# Product Support Bulletin 2008-010

## Maintenance of Way ~ Work Equipment Bulletin

**SUBJECT:** Lynch Pin Style Claw Pin Retainer – 53642483

**Figure 1**  
Hairpin Cotter – p/n 3074220

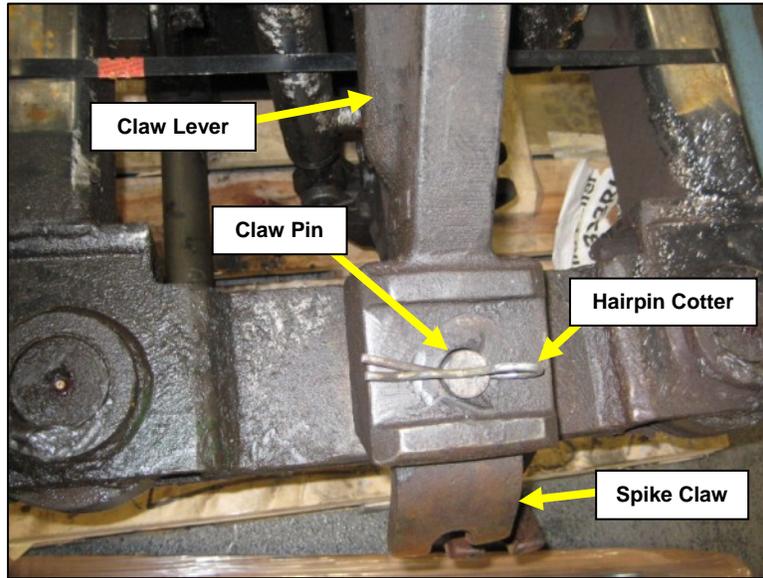
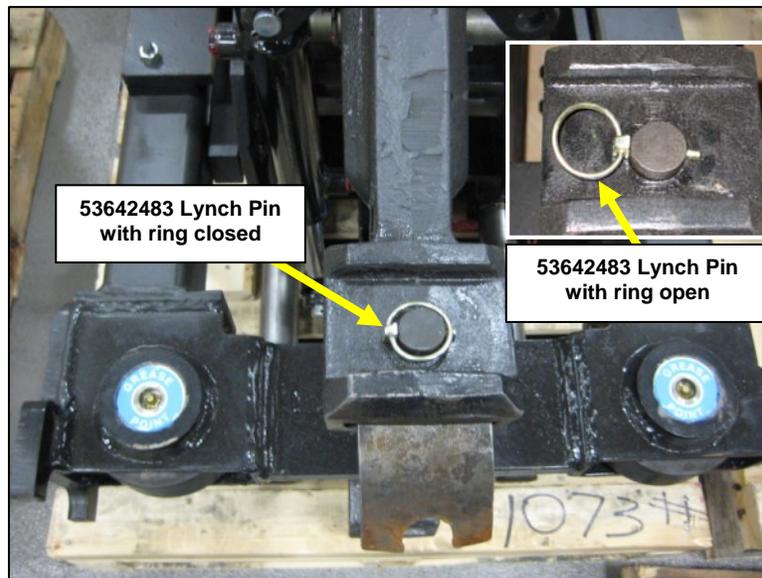
**SUMMARY:** The Hairpin Cotter, p/n 3074220 used to retain the Claw Pin in the end of the Claw Lever has been replaced with a Lynch Pin, p/n 53642483.

**OPERATIONAL IMPACT:** The 3074220 Hairpin Cotter is difficult to remove and can be damaged during machine operation. See Figure 1 on Page 2. The **53642483 Lynch Pin Retainer** is less likely to be damaged during use and is much easier to remove when replacing the Claws. It has a ring that snaps over the Claw Pin to keep the Lynch Pin in place. See Figure 2 on Page 2. When the ring is snapped open, the Lynch Pin is easily removed.

**ACTION:** The 53642483 Lynch Pin is a direct replacement for the 3074220 Hairpin Cotter. No modifications are required to the Claw Lever or Claw Pin.
